Independence Boulevard Area Plan  
Citizen Advisory Group Comment Sheet  
April 2, 2009

## 250' Proposed Right-of-Way from Briar Creek to Harris

## 250' Proposed Right-of-Way from Briar Creek to Harris

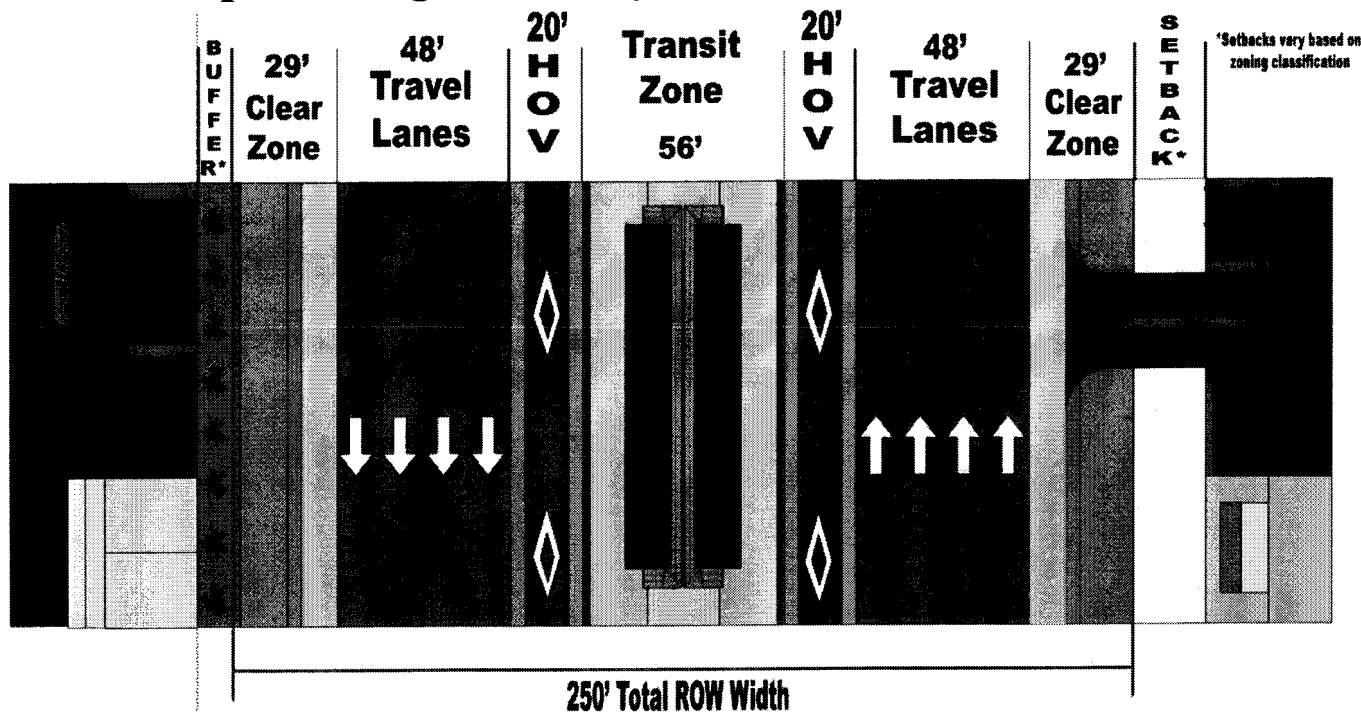
1. Do you think the potential reduction in the proposed right-of-way (ROW) by 100' (existing proposed ROW of 350' to new proposal of 250') will accommodate future transportation needs? Yes ☐ No ☒
2. Do you think the potential reduction in the proposed right-of-way (ROW) by 100' (existing proposed ROW of 350' to new proposal of 250') will accommodate future development needs? Yes ☐ No ☒

*REMOVE THE TRANSITIONAL SETBACK*

*East Charlotte, Needs the Economic Engine of Indep. Restored. Light Rail will foster TRANSIT ORIENTED DEVELOPMENT. WE NEED that Economic Engine.*

*BRT WILL NOT FOSTER TOD. IF Indep. becomes Freeway, then the CONNECTIVITY*

*REQUIRED for TOD WILL NOT EXIST. If the Freeway Concept is Implemented, ALL BUSINESS WILL FAIL. The EAST Quadrant WILL SUFFER.*

*Freeways & Interstates are to be NEWLY BUILT, in an area where No Current Thoroughfare exists. To take a Business Corridor/Highway; & slowly convert it to FREEWAY is UNETHICAL & SINISTER.*

## 280' Proposed Right-of-Way Beyond Harris Blvd.

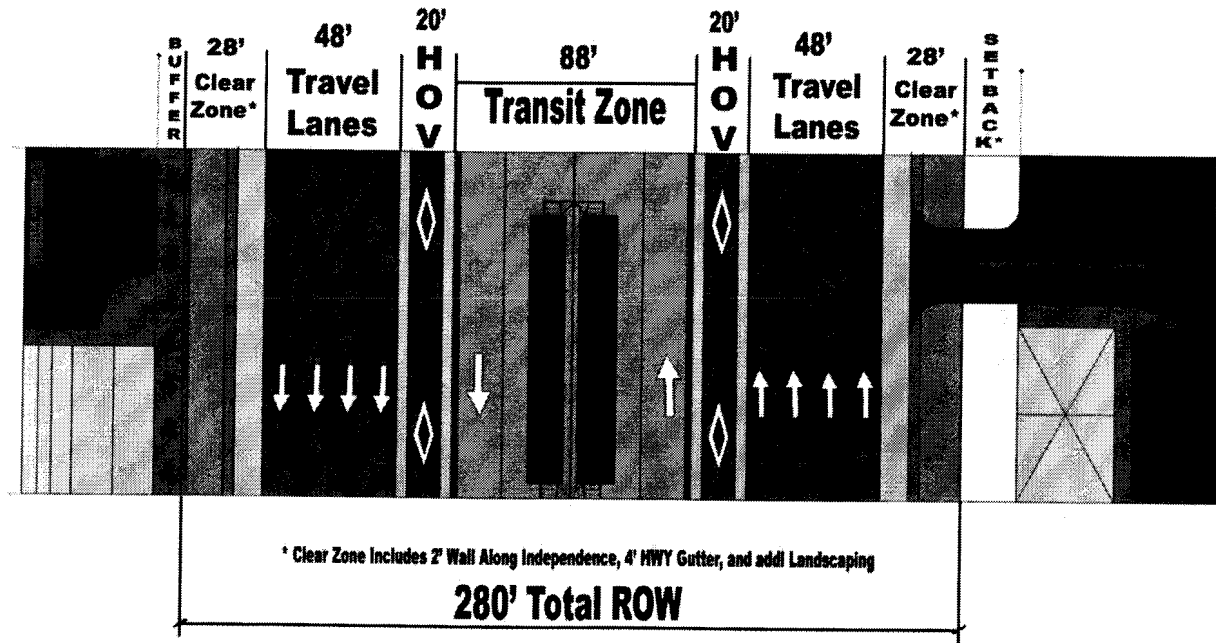
1. Do you think the potential reduction in the proposed right-of-way (ROW) by 70' (existing proposed ROW of 350' to new proposal of 280') will accommodate future transportation needs? Yes \_\_\_\_\_ No ✓

2. Do you think the potential reduction in the proposed right-of-way (ROW) by 70' (existing proposed ROW of 350' to new proposal of 280') will accommodate future development needs? Yes \_\_\_\_\_ No ✓

*NO Transitional Setback AT ALL.*

*Restore ALL Left Turns that was on Indep. The City of Charlotte CLAIMS that CONNECTIVITY is a PRIORITY. Making Indep. a Freeway VIOLATES this CLAIMED PRIORITY. That is an EXPLICIT EXAMPLE of how EAST CHARLOTTE is NOT Being Included in the Forward Momentum the Rest of the City is Enjoying.*

## 250' Proposed Right-of-Way from Briar Creek to Harris

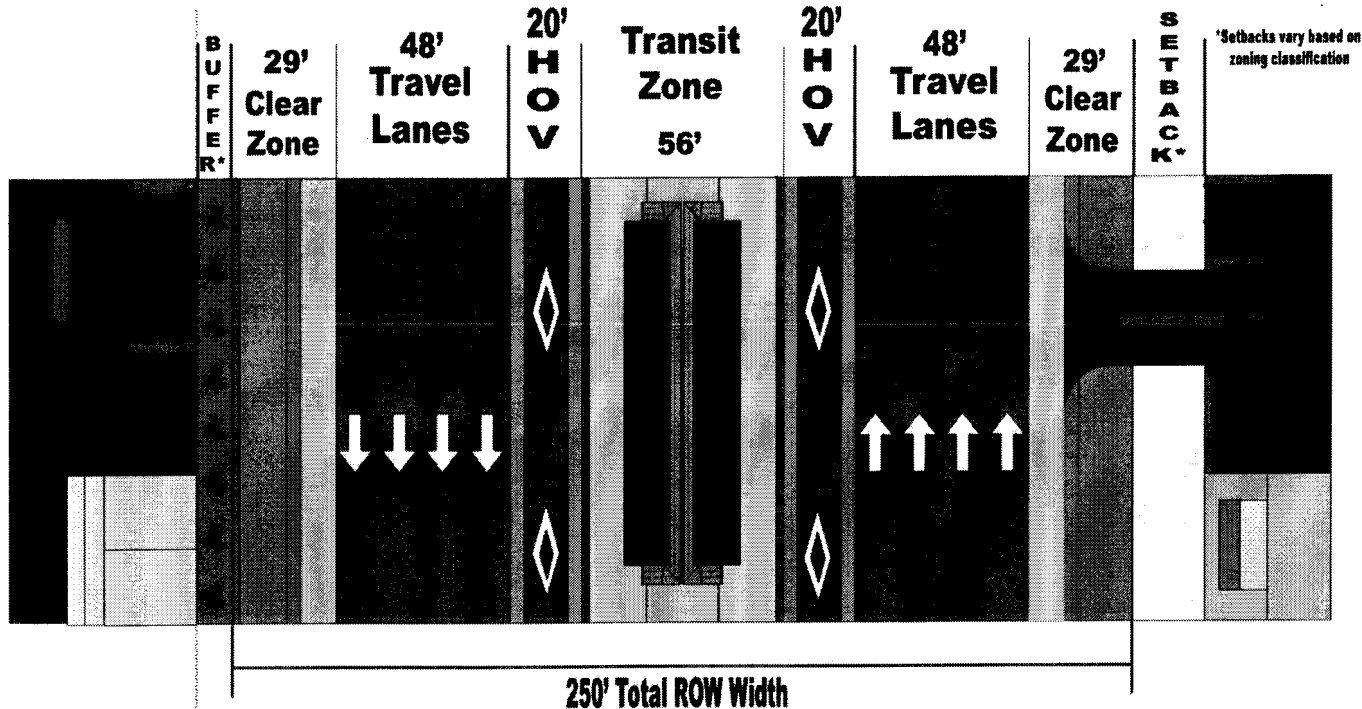
1. Do you think the potential reduction in the proposed right-of-way (ROW) by 100' (existing proposed ROW of 350' to new proposal of 250') will accommodate future transportation needs? Yes ☒ No ☐
2. Do you think the potential reduction in the proposed right-of-way (ROW) by 100' (existing proposed ROW of 350' to new proposal of 250') will accommodate future development needs? Yes ☒ No ☐

BUY OUT THE PROPERTY OWNERS FROM BRIAR CREEK TO ALBEMARLE RD.  
ON THE NORTH SIDE. BUILD BUFFER WALL + ADD GRASSY WALL.  
LET CURRENT OPERATING BUSINESSES MOVE TO CENTAL AVE. + MONROE ROAD.

## 250' Proposed Right-of-Way from Briar Creek to Harris

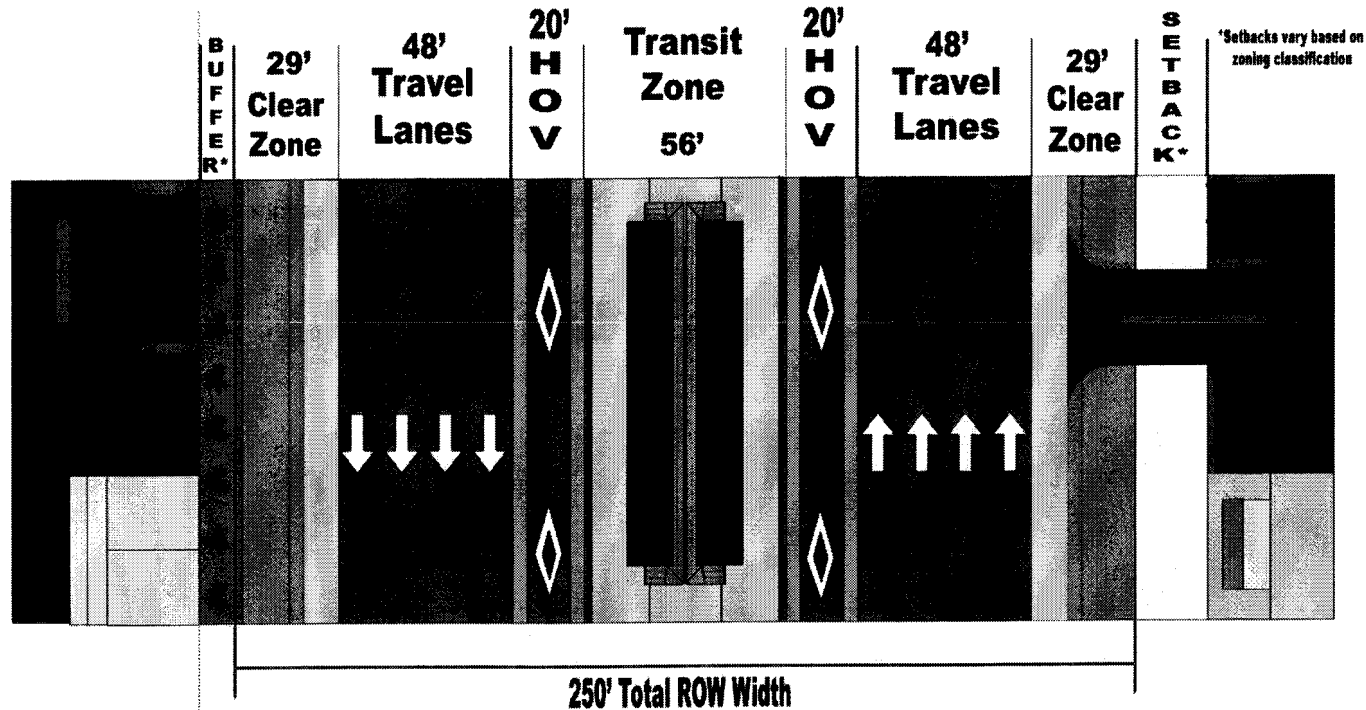
1. Do you think the potential reduction in the proposed right-of-way (ROW) by 100' (existing proposed ROW of 350' to new proposal of 250') will accommodate future transportation needs? Yes ☒ No ☐
2. Do you think the potential reduction in the proposed right-of-way (ROW) by 100' (existing proposed ROW of 350' to new proposal of 250') will accommodate future development needs? Yes ☒ No ☐

It is very comforting to see the plan in action. I do agree that the development needs to be staged, and I really wish for the section between Briar Creek - Sharon Amity will become primarily a buffered green way w/ some small business or a recreational facility (like a bowling alley)

## 250' Proposed Right-of-Way from Briar Creek to Harris

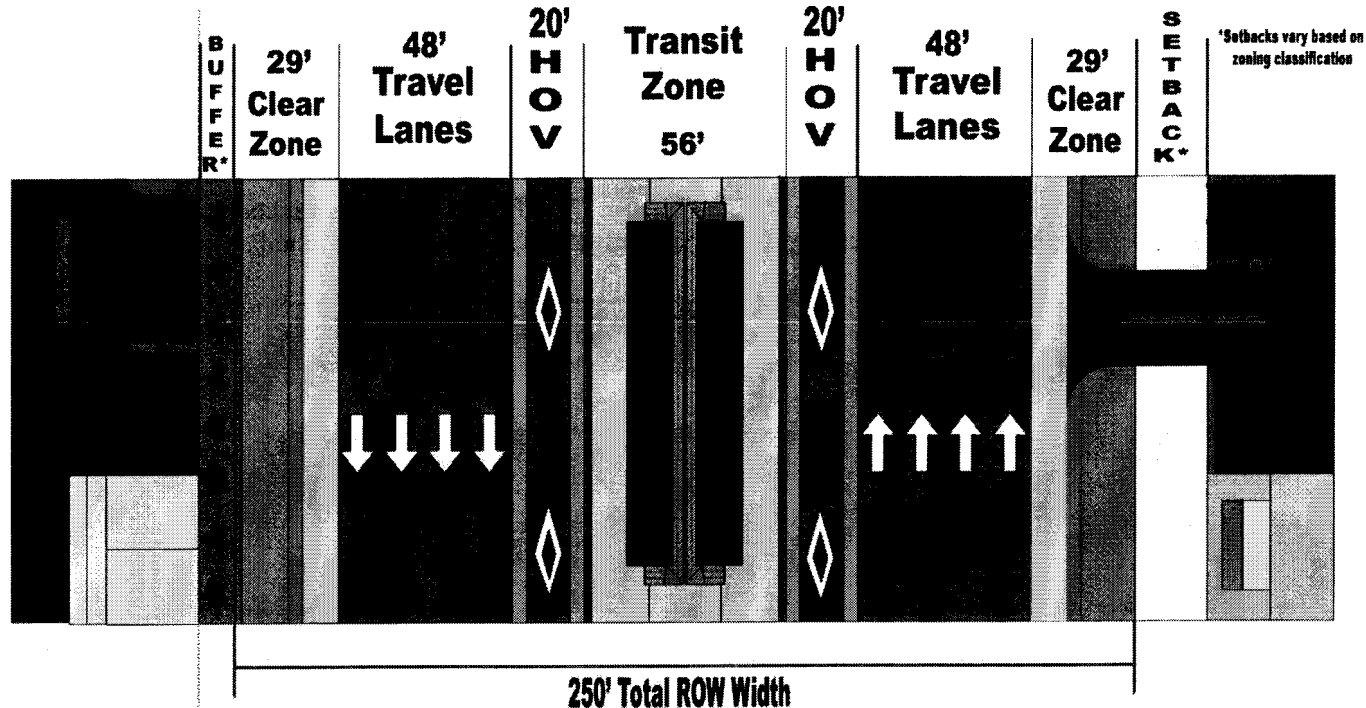
1. Do you think the potential reduction in the proposed right-of-way (ROW) by 100' (existing proposed ROW of 350' to new proposal of 250') will accommodate future transportation needs? Yes ☒ No ☐
2. Do you think the potential reduction in the proposed right-of-way (ROW) by 100' (existing proposed ROW of 350' to new proposal of 250') will accommodate future development needs? Yes ☒ No ☐

WHERE POSSIBLE - I.E. OLD COLISEUM SHOPPING CENTER - INCREASE BEYOND THE 250' IN ORDER TO CREATE ADDITIONAL LANDSCAPE/BUFFER AREA THEREBY ADDING VALUE TO PROPERTY

## 250' Proposed Right-of-Way from Briar Creek to Harris

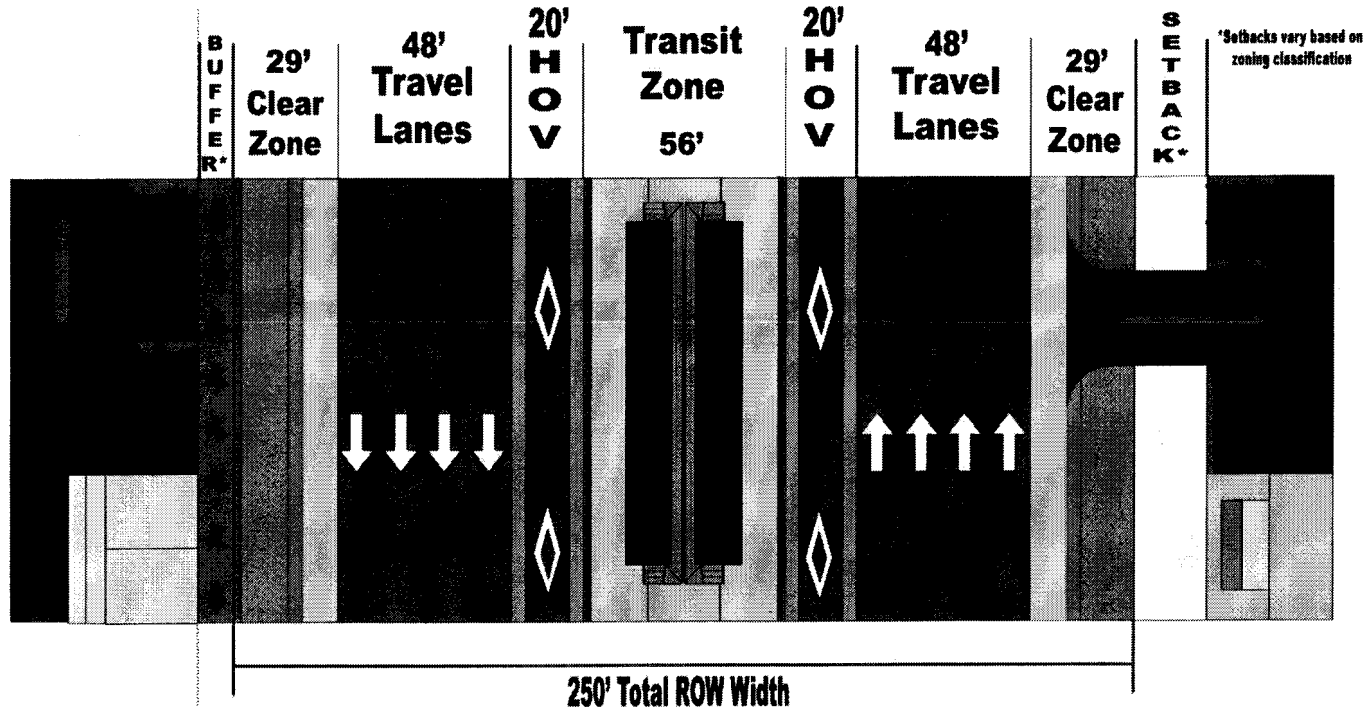
1. Do you think the potential reduction in the proposed right-of-way (ROW) by 100' (existing proposed ROW of 350' to new proposal of 250') will accommodate future transportation needs? Yes ☒ No ☐
2. Do you think the potential reduction in the proposed right-of-way (ROW) by 100' (existing proposed ROW of 350' to new proposal of 250') will accommodate future development needs? Yes ☐ No ☒

WITH NO LEFT TURNS ALLOWED AND NO  
ROAD CONNECTIONS FROM OTHER STREETS ON  
MANY PROPERTIES, DEVELOPMENT IS NOT POSSIBLE  
OR FEASIBLE!

## 280' Proposed Right-of-Way Beyond Harris Blvd.

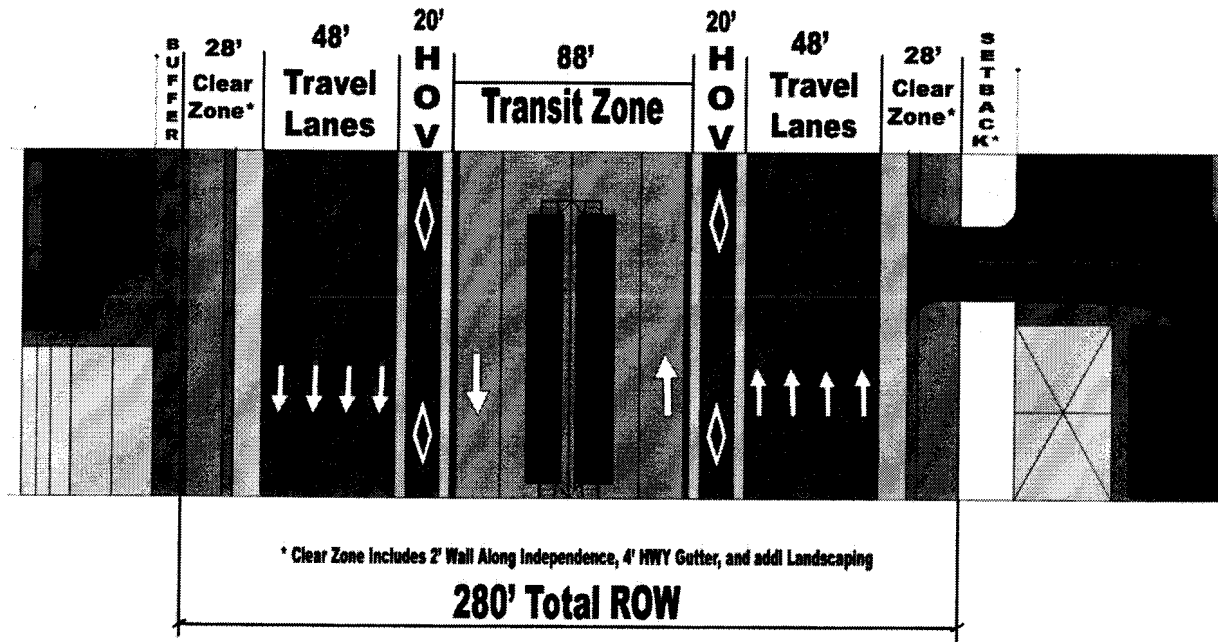
1. Do you think the potential reduction in the proposed right-of-way (ROW) by 70' (existing proposed ROW of 350' to new proposal of 280') will accommodate future transportation needs? Yes ☒ No ☐
2. Do you think the potential reduction in the proposed right-of-way (ROW) by 70' (existing proposed ROW of 350' to new proposal of 280') will accommodate future development needs? Yes ☐ No ☒

BUY LAND AND MAKE ROAD A  
FREEWAY AS PROPOSED AND NEEDED<sup>2</sup>  
BY NCDOT

## 250' Proposed Right-of-Way from Briar Creek to Harris

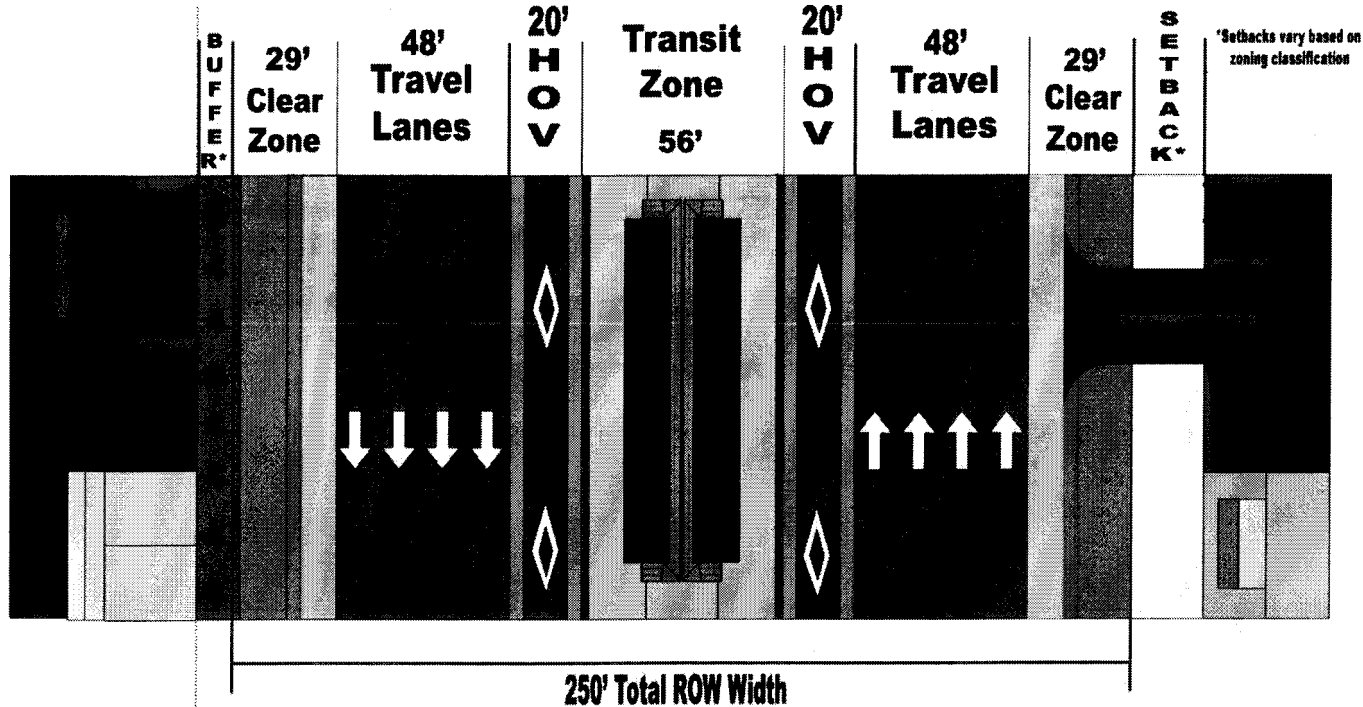
1. Do you think the potential reduction in the proposed right-of-way (ROW) by 100' (existing proposed ROW of 350' to new proposal of 250') will accommodate future transportation needs? Yes ☒ No ☐
2. Do you think the potential reduction in the proposed right-of-way (ROW) by 100' (existing proposed ROW of 350' to new proposal of 250') will accommodate future development needs? Yes ☒ No ☐

*Removing traffic lights will increase capacity. Increase access from Monticello Central.*  
*Reducing the ROW will encourage more development*  
*Light rail will increase business opportunities.*  
*Don't continue what's been done!*

## 250' Proposed Right-of-Way from Briar Creek to Harris

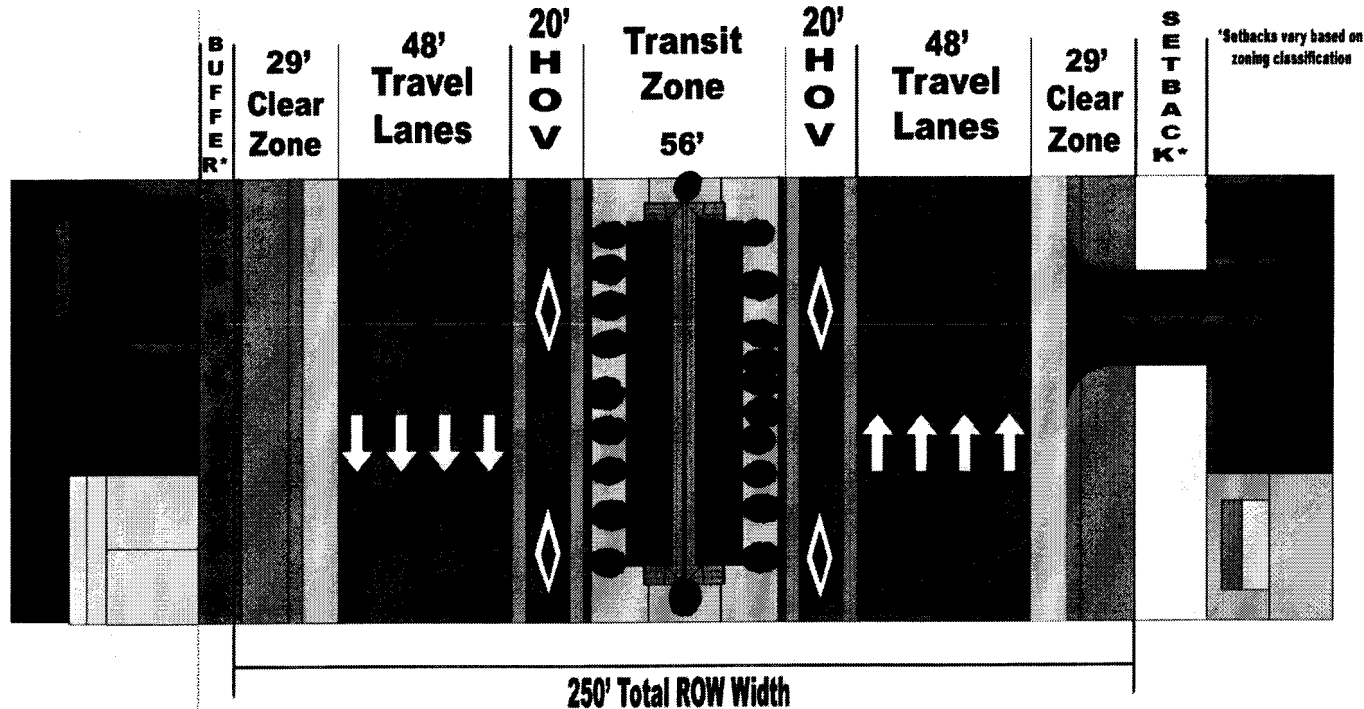
1. Do you think the potential reduction in the proposed right-of-way (ROW) by 100' (existing proposed ROW of 350' to new proposal of 250') will accommodate future transportation needs? Yes ☒ No ☐
2. Do you think the potential reduction in the proposed right-of-way (ROW) by 100' (existing proposed ROW of 350' to new proposal of 250') will accommodate future development needs? Yes ☐ No ☒

This plan is so far off. There is no way this will get funded in the next 30 years. Obviously if you look at this, it took 30 years to widen to 150 ft + three miles to Sharon Amity. There is no money to buyout undevelopable property. Better to give to community + developers. Reduce ROW 200-225 ft. Still 111 buildings in the setback Elizabeth Ave Condos much closer than this - I-77 carries 170K cars a day w/ 2 lanes in each direction. Indy already wider than that and doesn't carry that much. I-77 is congested but ~~not~~ does not require Mass transit + 6 lanes each direction.

## 280' Proposed Right-of-Way Beyond Harris Blvd.

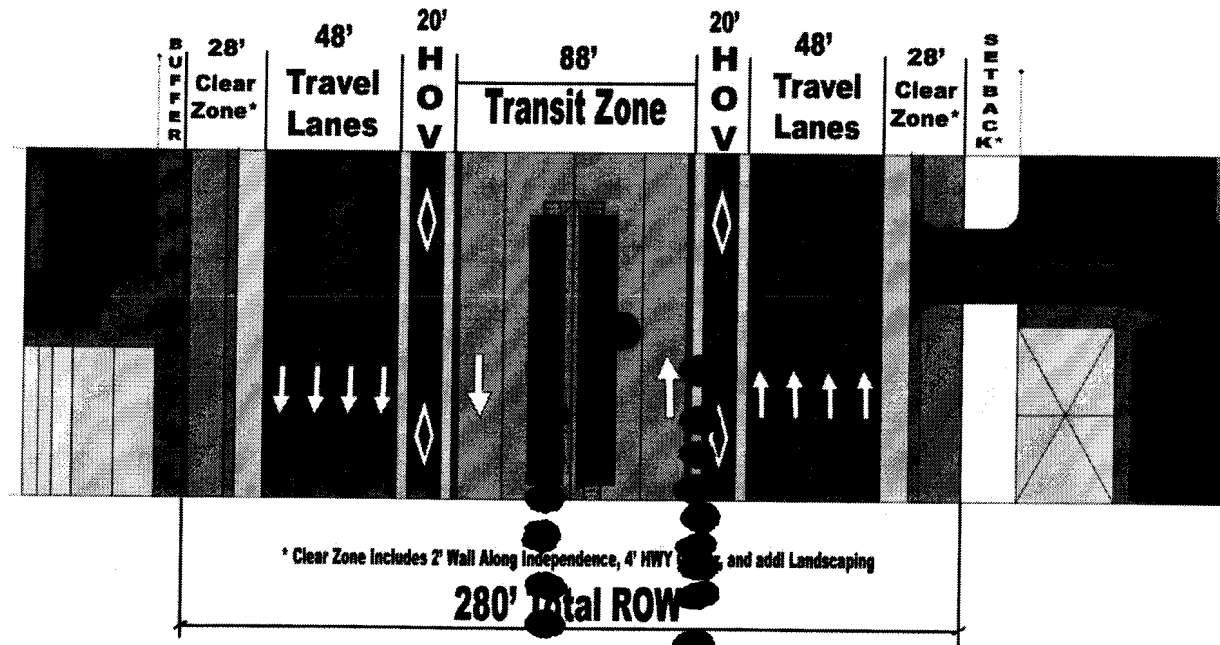
1. Do you think the potential reduction in the proposed right-of-way (ROW) by 70' (existing proposed ROW of 350' to new proposal of 280') will accommodate future transportation needs? Yes ☒ No ☐
2. Do you think the potential reduction in the proposed right-of-way (ROW) by 70' (existing proposed ROW of 350' to new proposal of 280') will accommodate future development needs? Yes ☐ No ☒

There is no money for widening. This section hasn't been widened to 150 yet (nowhere close). Nevermind cleaning up the aftermath of undevelopable property. And now there is a plan to double the width of the road. No way it's going to happen in 30 years. Still all buildings in setback. Reduce setback more 200-225 ft ROW Elizabeth Ave condos much closer. If I-77 already carries future forecast of Independence. 2 Granted @ I-77 is congested, it won't take BRT / LRT HOV etc to fix it, Much less widening needed to carry 170K cars a day
